Item No. AD-1.4:                    Reference Deleted Sections

Item No. AD-1.11:                    Reference Revised Drawings

RESPONSES AND VARIOUS CLARIFICATIONS TO  
F13-13 INDIAN SPRINGS HIGH SCHOOL ATHLETIC COMPLEX

**INDIAN SPRINGS  
ATHLETIC COMPLEX**

Drawing No. E3.0

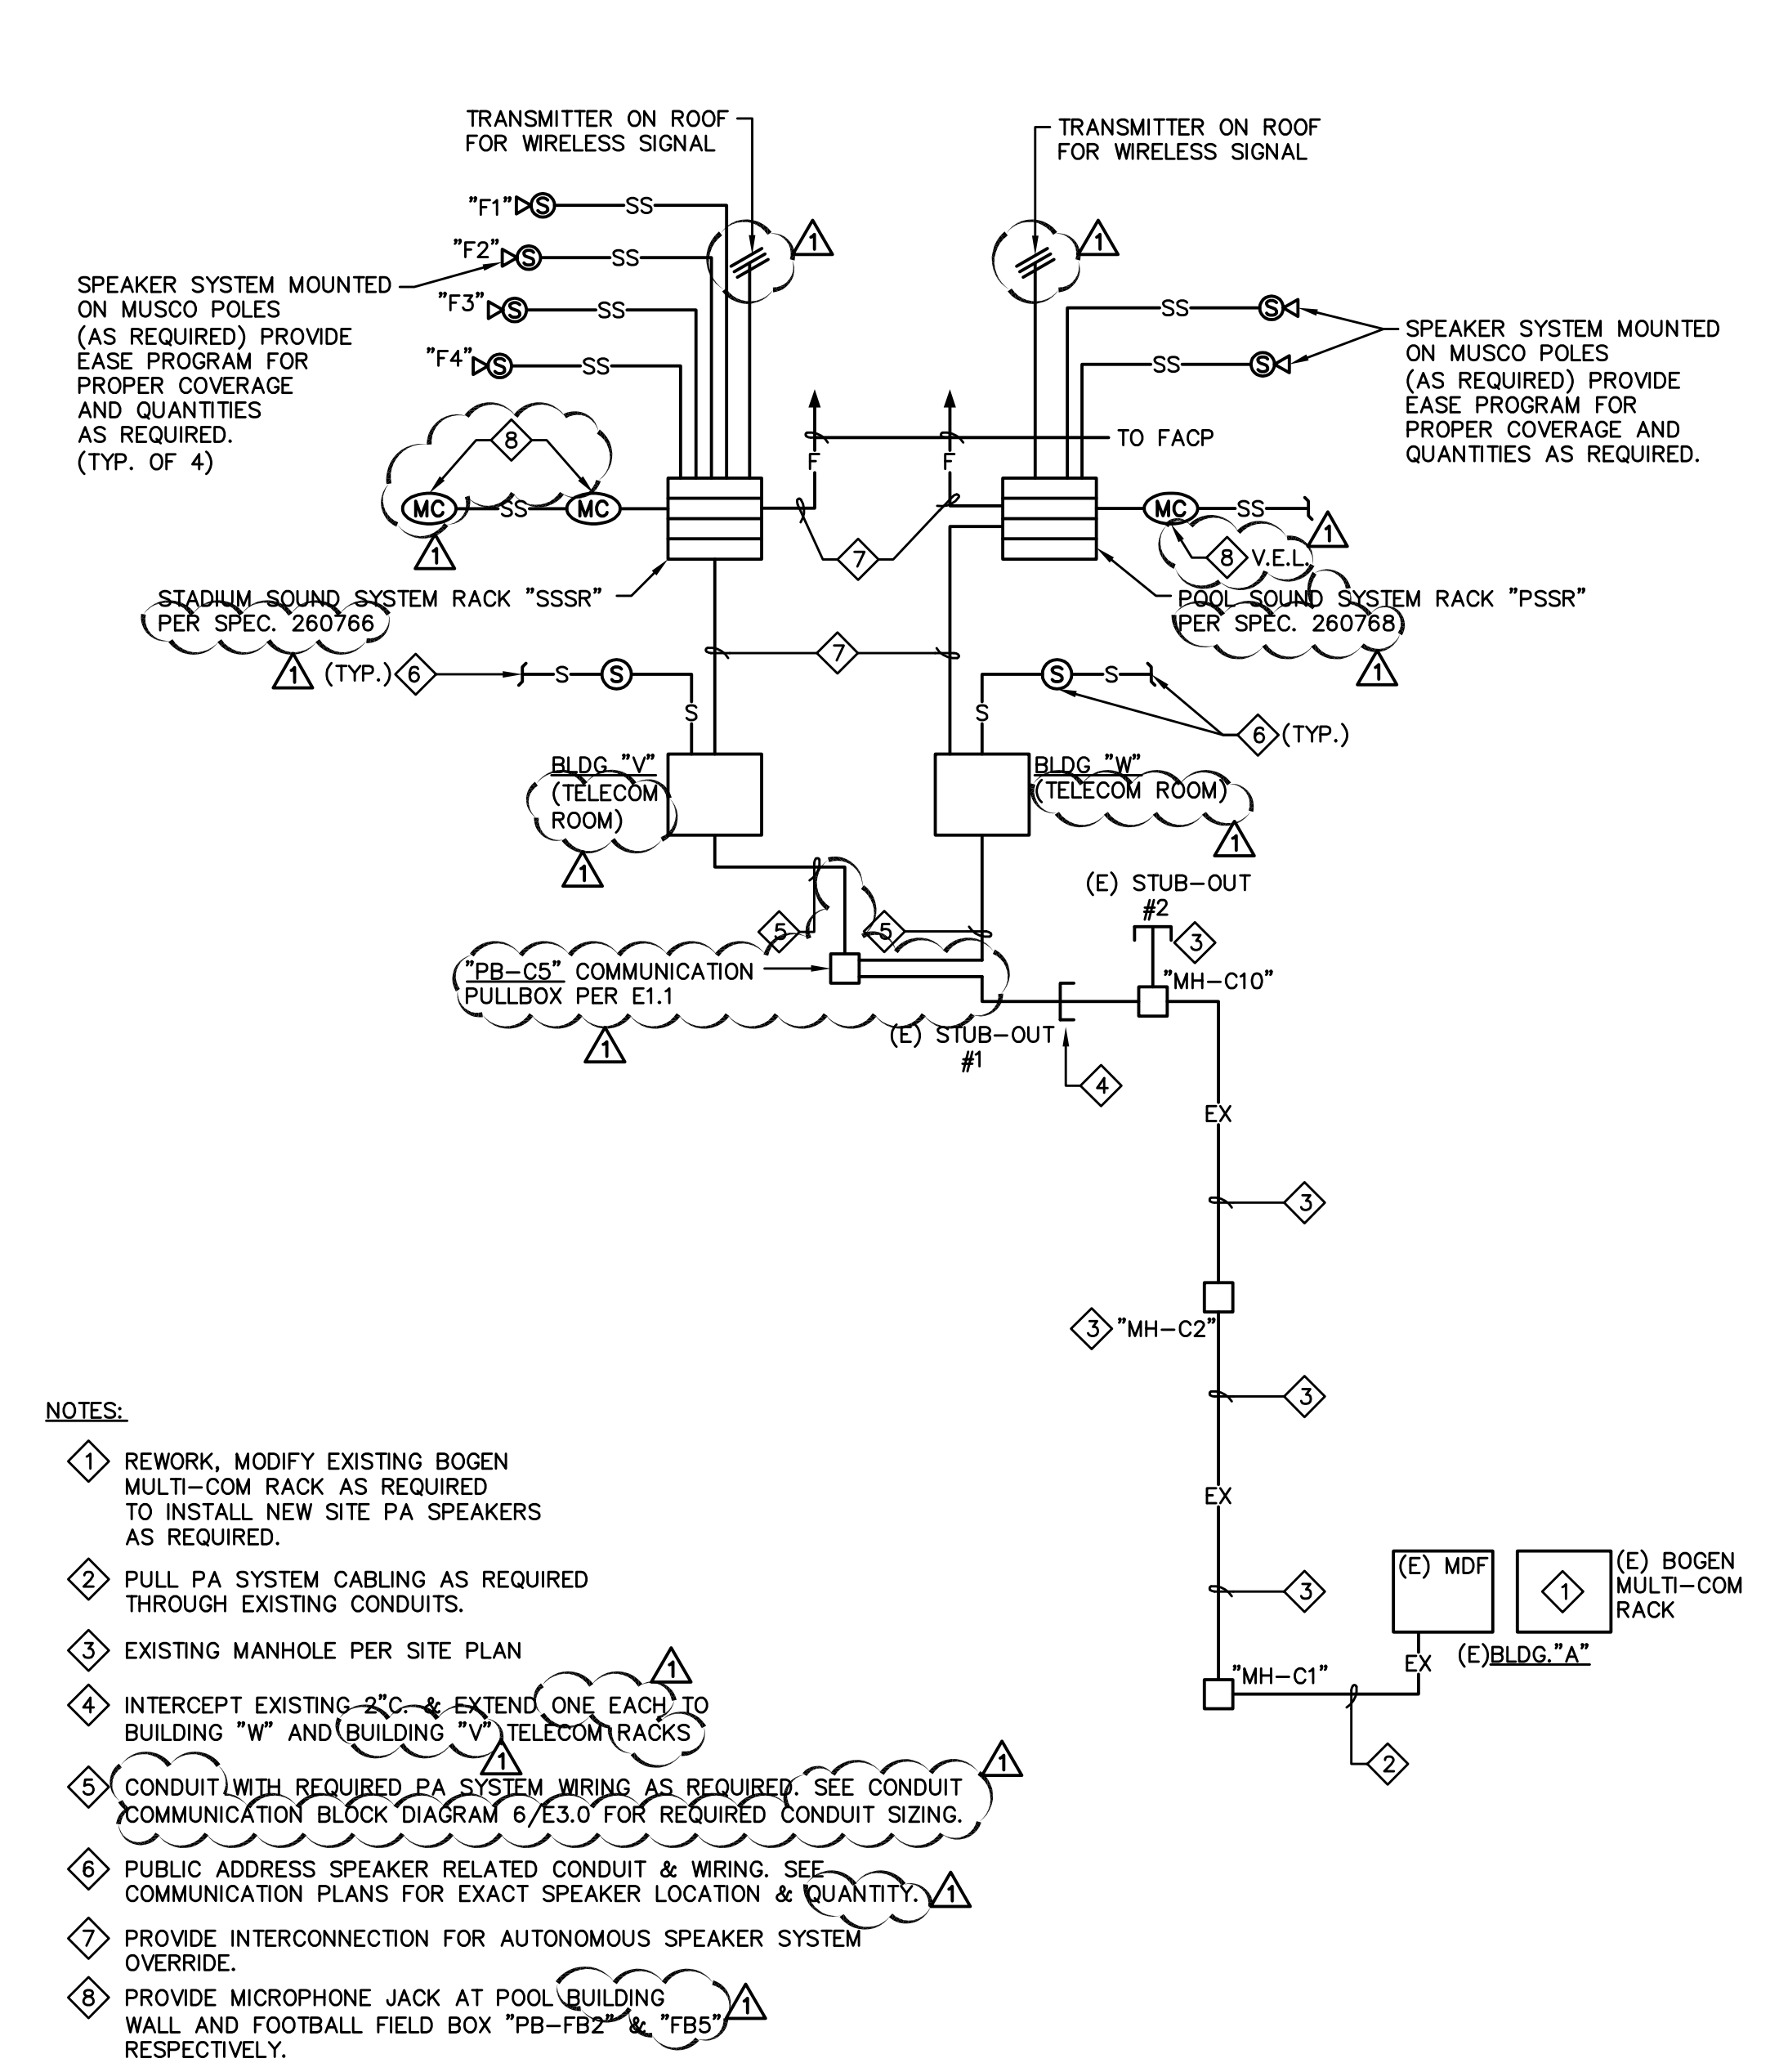
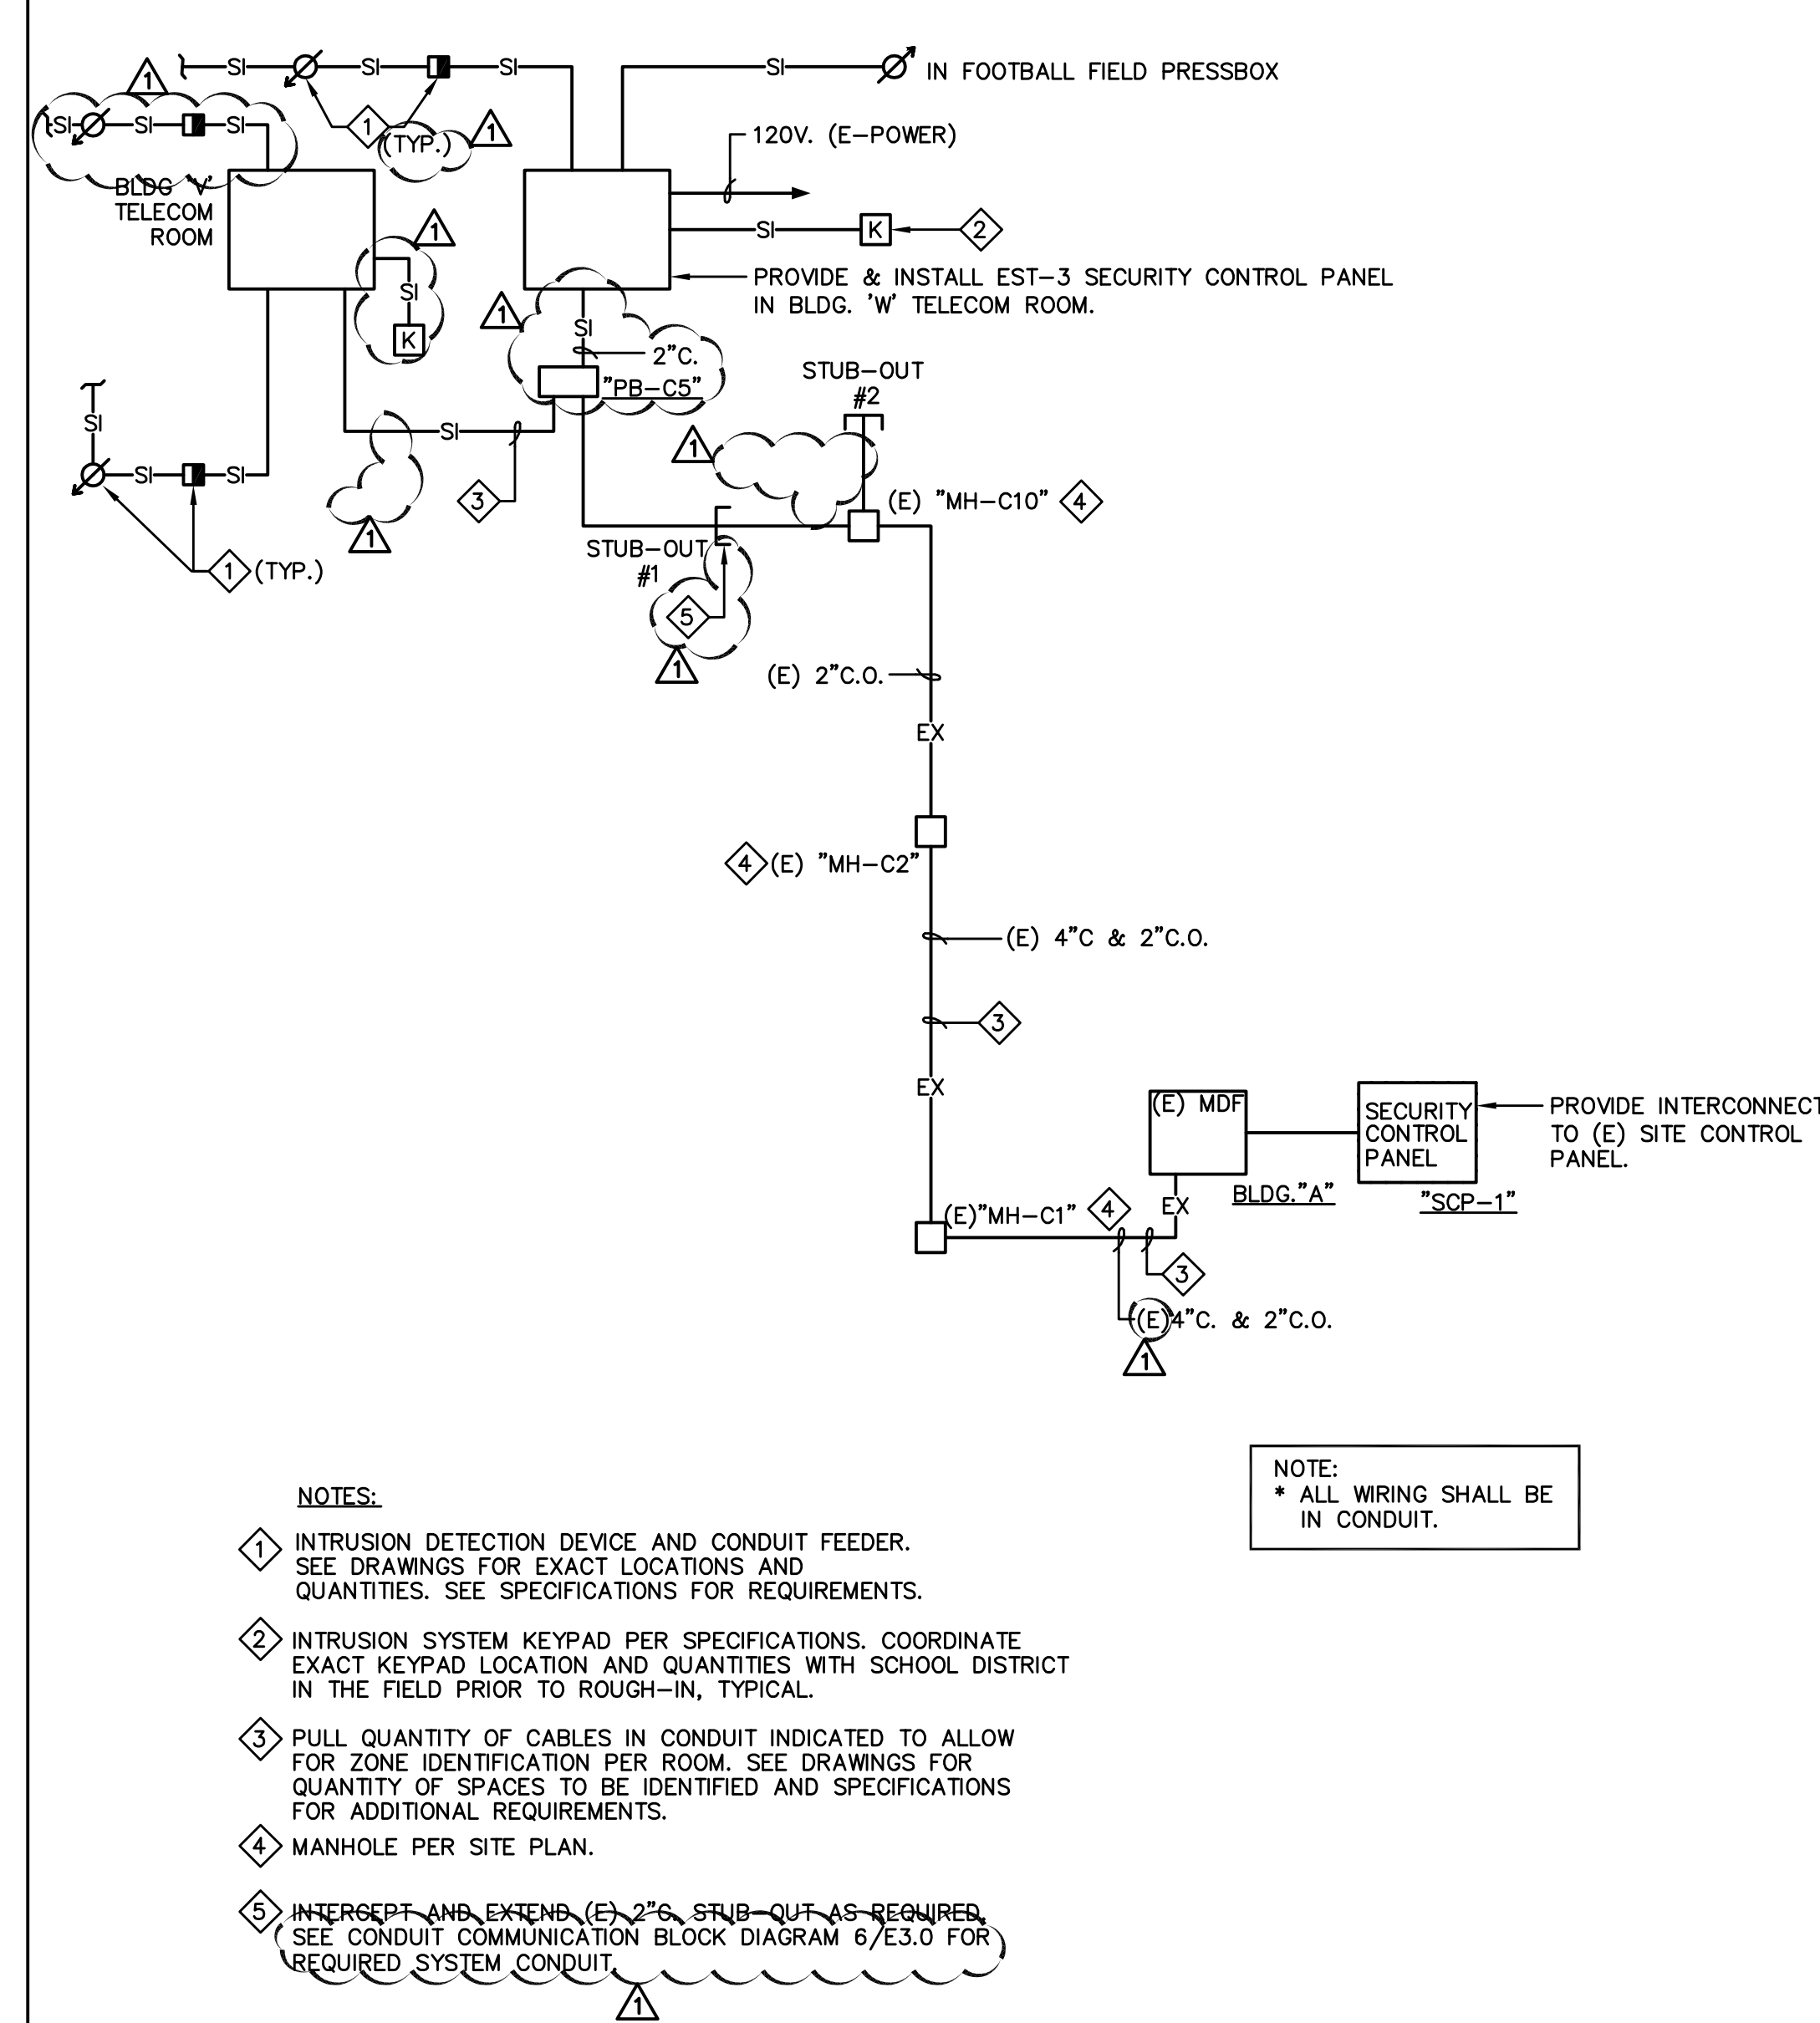
AD-1.01 (Reference A1.30)  
AD-1.02 (Reference E1.1, Electrical Site Plan)  
AD-1.03 (Reference E3.0, Communication Riser Diagrams)
